**Site Address: 27 NAUTILUS CT SAC**  
Parcel No: 030-0740-008 27 NAUTILUS CT

**Nature of Work: REROOF WITH LITE TILE .**

**ROOF PLAN - LEUNG**

Subject: Structural Investigation Report of the Roof for the Residence located at 27 Nautalis Court, Sacramento, CA 95831

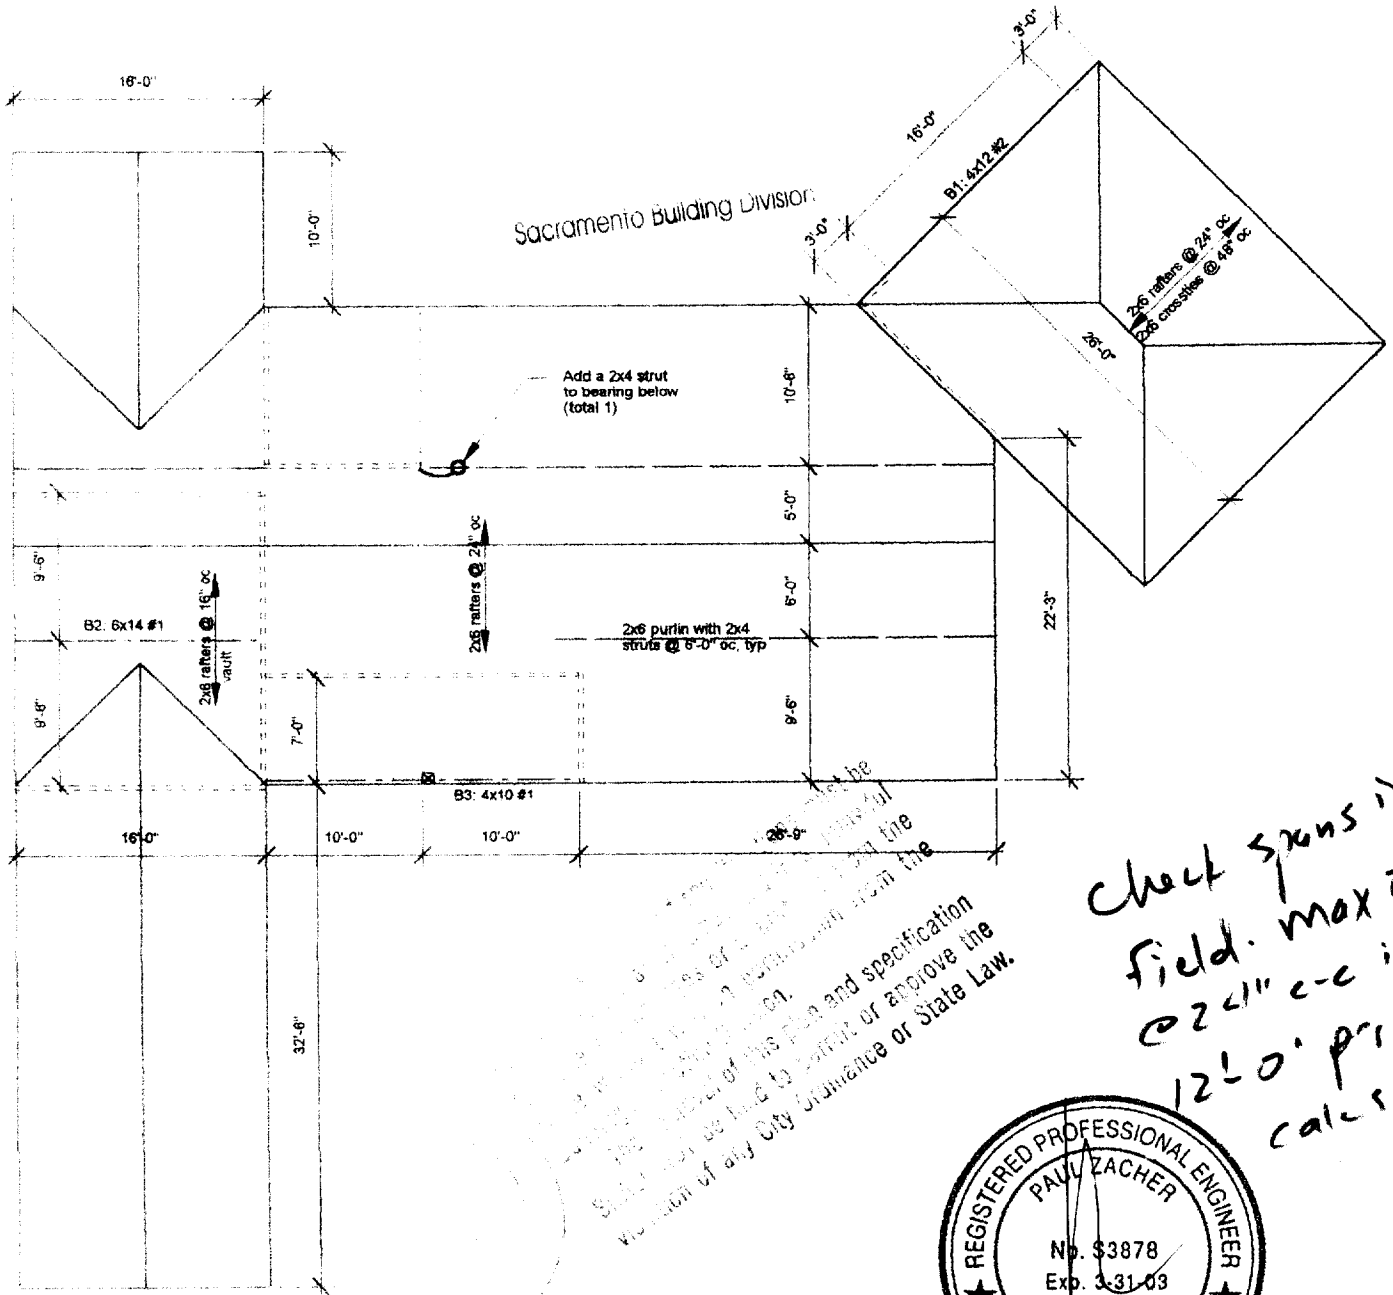
Check spans in field. Max 2x6 @ 24" c-c is 12'-0" per the calc's.
